**Amendments To The Drawings:**

### **REMARKS/ARGUMENTS**

Application Serial No. 10/663/069  
Reply to Office Action of 09/18/2006

FIG. 6

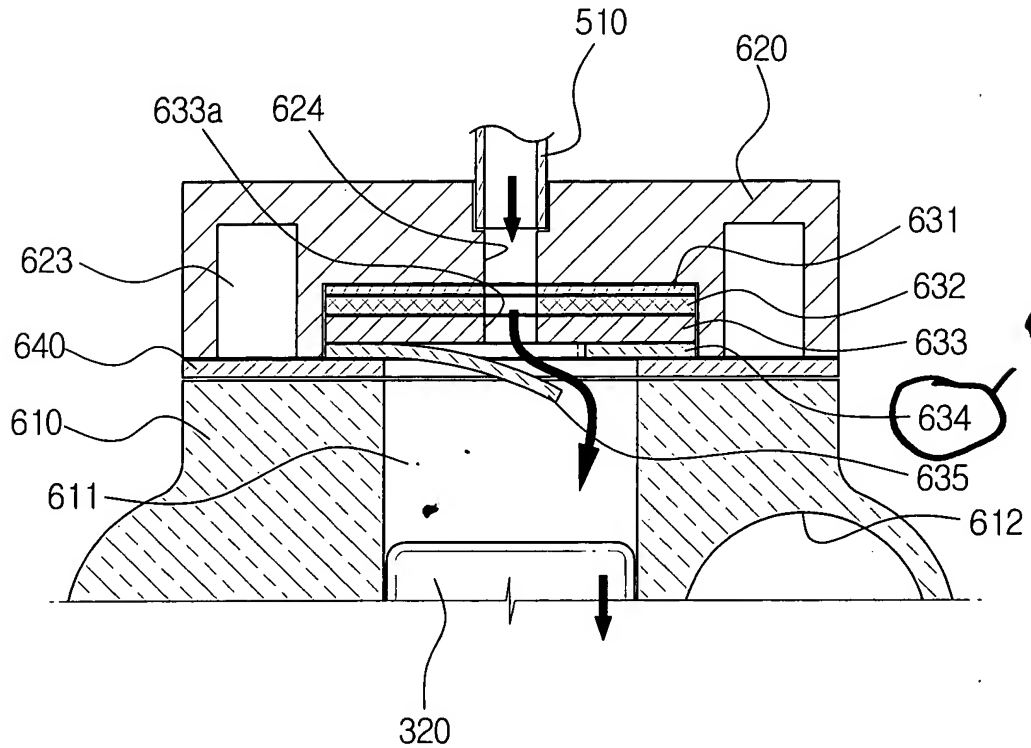
In the office action, the drawings were objected to because reference numeral 624 identifies two different structures in FIG. 6. In response to the drawing objection, the applicant is submitting an amended FIG. 6, which deletes one instance of reference numeral 624 and replaces it with reference numeral 634. The revision to FIG. 6 is encircled in red on the attached annotated sheet. The revision is hidden on the attached replacement sheet for FIG. 6 and 7.
